Technical Note

Project:	Finchwood Park Parcel 13	SMA Ref:	7292.TN05
Subject:	Response to WBC Drainage Comments	Revised:	–
Prepared by:	Tyler Andrews	Date:	22.07.2025
Checked by:	Kate Marshall	Date:	23.07.2025

FINCHWOOD PARCELS 11, 12 & 13

PARCEL 13
PROPOSED DRAINAGE

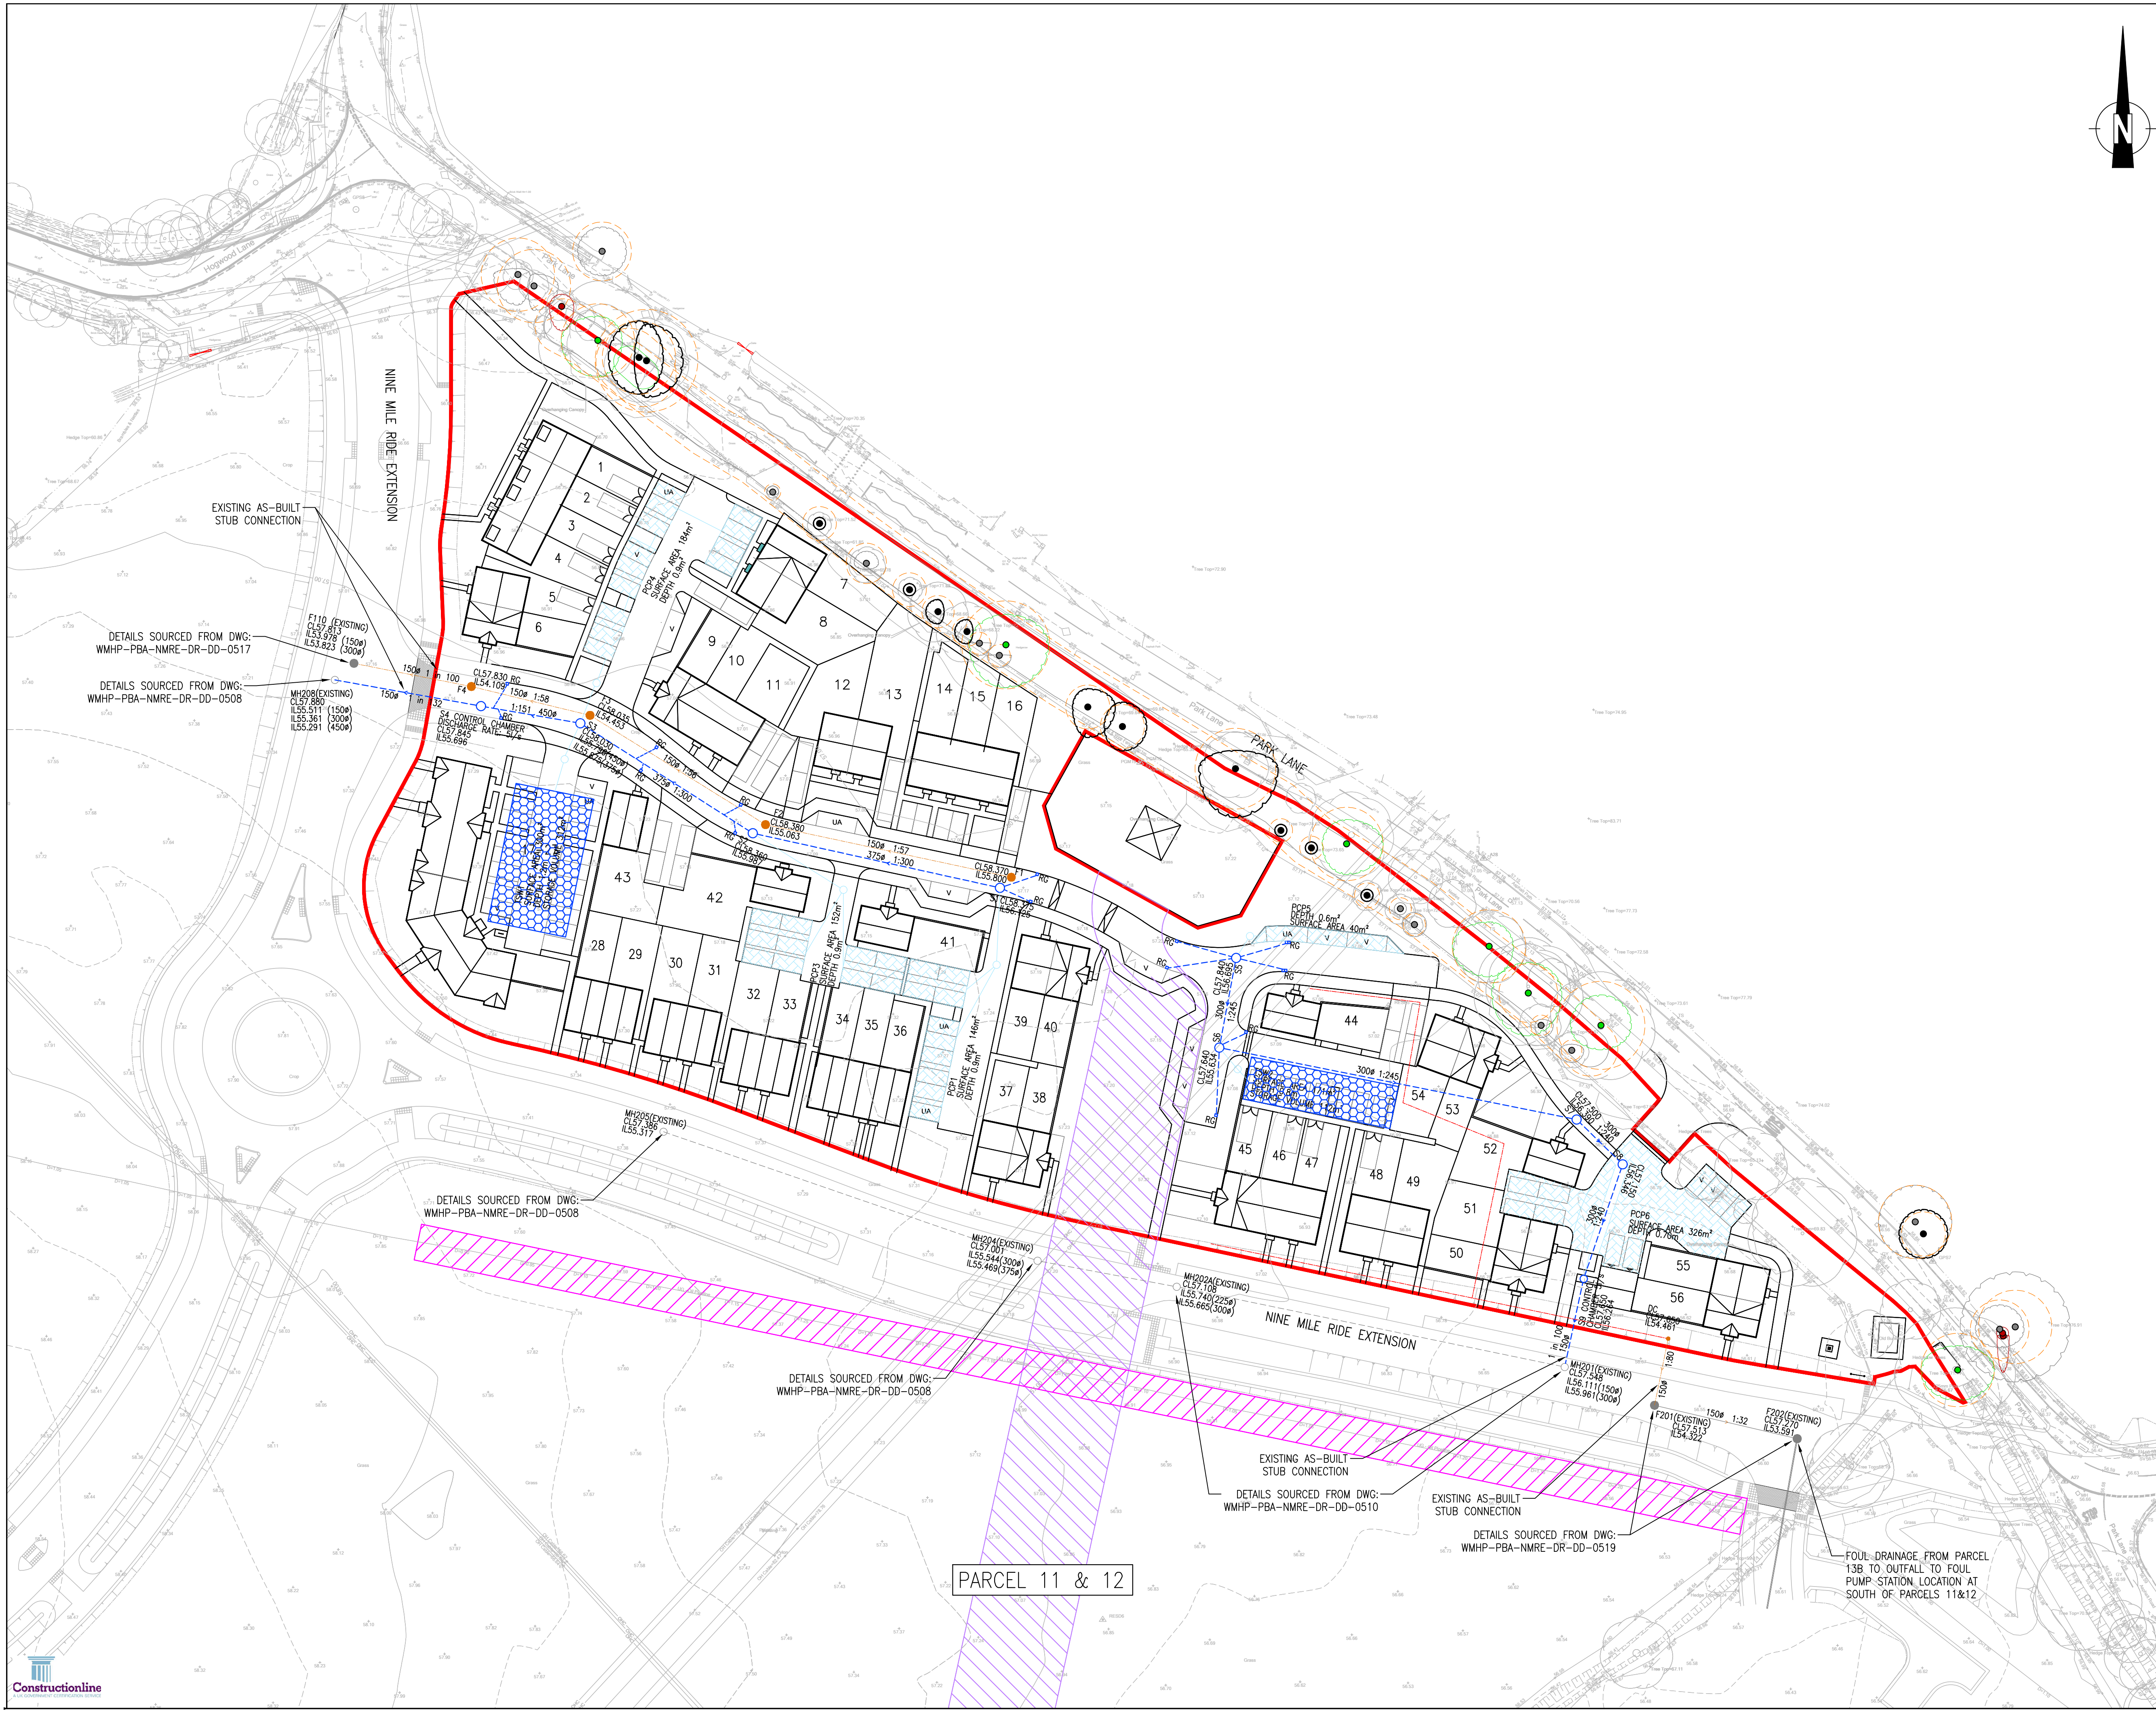
Sub parcel 13a provides attenuation for the 1 in 100-year flood event with a 40% allowance for climate change, with discharge controlled at the agreed outline rate of 5l/s, from the western end of the site. Sub parcel 13b also provides attenuation with discharge controlled from 2 points at 3.3l/s and 1.7l/s to represent the agreed 5l/s discharge from this parcel. This is as represented on the drainage strategy drawing in Appendix A.

*The causeway flow calculations dated 28/02/2025 (Appendix B) indicate that there is no flooding for events up to and including the 1 in 100-year flood event with a 40% allowance for climate change. **Ideally there should be no surcharging for the 2-year event but there seems to be some surcharging for the 2-year event for parcel 13a. Please check this and amend.***

*Also please **provide the causeway pfd files** so that we can audit the results.*

The most recent updates to the Parcel 13 drainage strategy mean that there are now only 2 discharge points as discussed in the meeting on 16th July 2025**. Parcel 13B now only has one discharge point due to a change in site constraints. The design and calculations have been updated appropriately.

The surcharging during the 2-year storm event is now present in both 13a & 13b at manholes S4 & S9 respectively. This is due to the as-built stubs the manholes connect onto only being 150mm diameter, and these manholes being the point at which the respective parcels flow controls are located. The flow controls for each discharge point are both restricted to 5l/s. This means that during all storm events,

surface water needs to back up from the flow control to the nearest surface water storage and this creates the surcharging of the flow control manholes.

The causeway PFD files are now included as requested for auditing purposes.
